TOWN OF DAVIE

TOWN COUNCIL AGENDA REPORT

SUBJECT: Site Plan, SP 5-1-03 Sheridan House Plat No. 3, Miller Legg & Associates, Inc./Sheridan House, Inc., 1700 Flamingo Road/ Generally located at the southeast corner of Flamingo Road and SW 14 Street

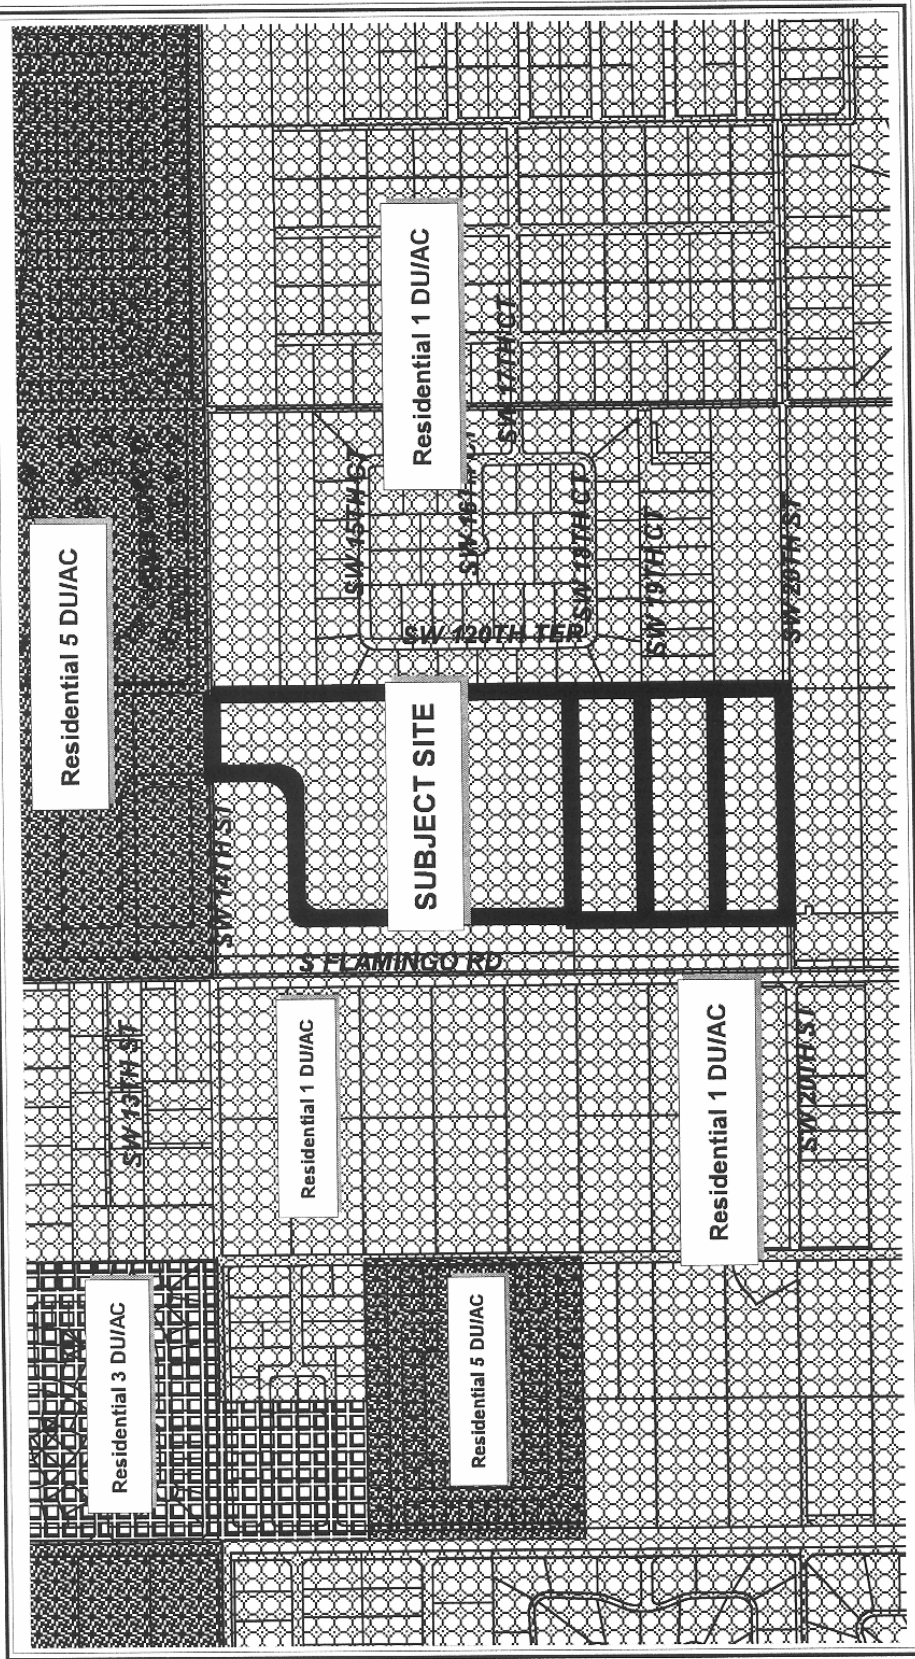
At the November 25, 2003 Site Plan Committee Meeting, Vice-Chair Evans made a motion, seconded by Mr. Engel, to approve based on the planning report and these added items: 1) that the intersection of the main boulevard, after the gate house, have a four-way stop and be

reviewed by Engineering for safety concerns; 2) that on the phase one plan, the maintenance building, dumpsters and the related parking lot, be put back on the phase one plans; 3) that at most of the residences, the general parking areas be pulled away from the buildings so that there is sufficient backup room for vehicles coming out of the dead end parking on these small parking lots; 4) that the administration building will have a metal roof, not shingles as shown on the plans; 5) that a sidewalk be added from the parking area to the front doors of each building; 6) that there be a sidewalk added from each residence meeting room to the parking lot; 7) that the three main median entrance trees are to be increased to 20-foot overall height and it is noted that it will not match what the rendering showed; 8) change the Saw Palmettos on the east side of the berm to Coco Plums at 24 inches in height, 36 inches on center; 9) have the drop-off driveway going to the daycare center and through the porte cochere be designated as a one-way drive; and 10) that everything will have to meet ADA compliance, the same as discussed on the gatehouse. (Motion carried 4-0)
